Parking Brake Warning Light On With DTC C059746

Service Category Brake

Section Parking Brake

YEAR(S)	MODEL(S)	ADDITIONAL INFORMATION
2020 - 2021	Corolla, Corolla Hatchback, RAV4

Figure 1. Parking Brake Malfunction Warning Message

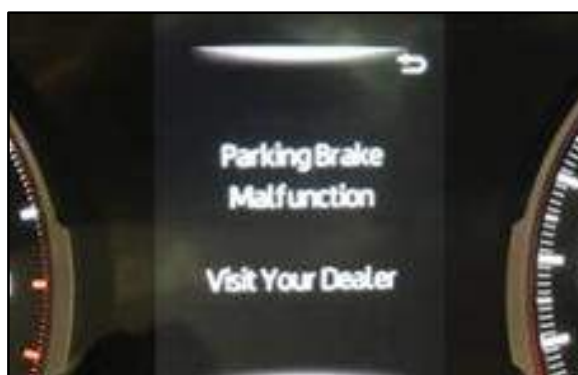
Some 2020 – 2021 model year Corolla, Corolla Hatchback, and RAV4 vehicles may exhibit a Parking Brake Malfunction warning message on the Multi-information Display (MID) with Diagnostic Trouble Code (DTC) C059746 (Brake System Control Module "A" Calibration / Parameter Memory Failure) present. Follow the Repair Procedure in this service bulletin to address this condition.

Figure 2. Location of Authorized Modifications Label on 2020 – 2021 model year Corolla, Corolla Hatchback, and RAV4

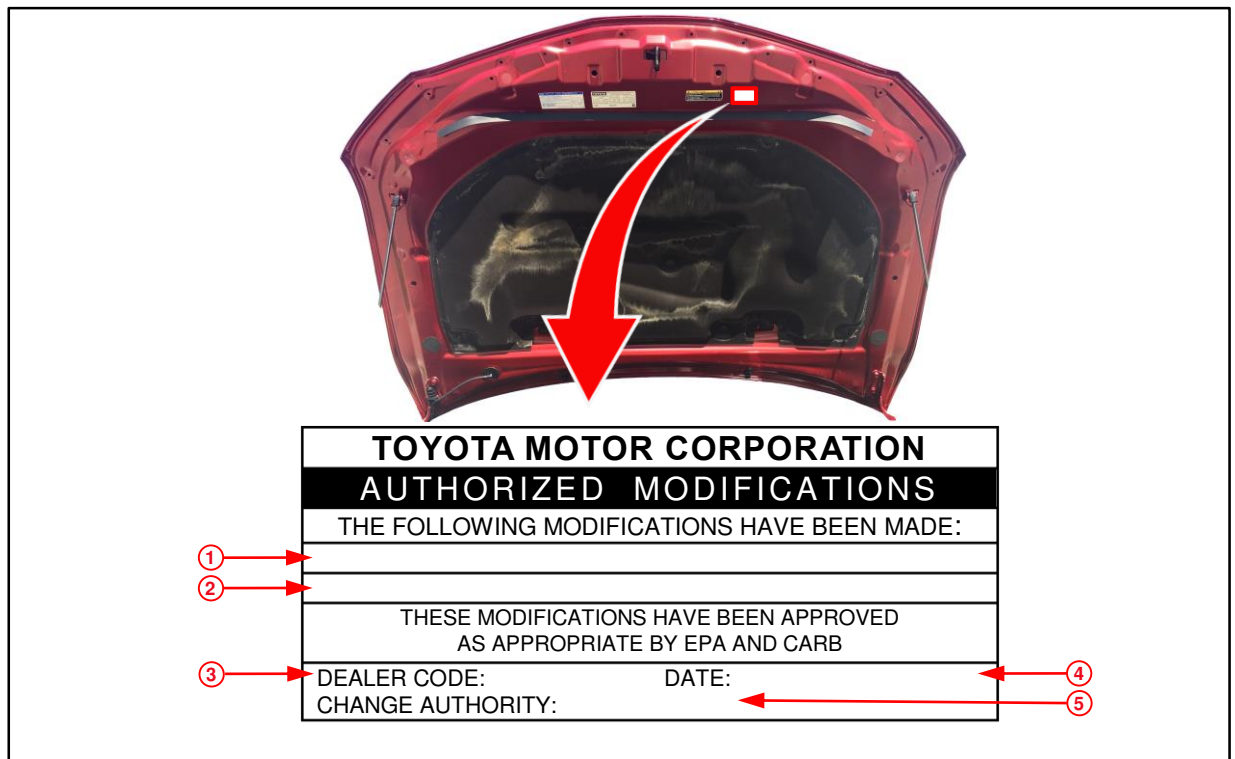
2. Use Techstream to confirm if the skid control computer calibration has been updated and check for the Authorized Modifications Label affixed to the vehicle in the location shown below.

Is the calibration ID listed in Techstream and on the label the latest skid control computer calibration?

1	Replacement Skid Control Computer Part Number e.g., 89541-12C10
2	New Calibration ID e.g., F15264271300
3	Dealer Code

4	Date Completed
5	This SB Number
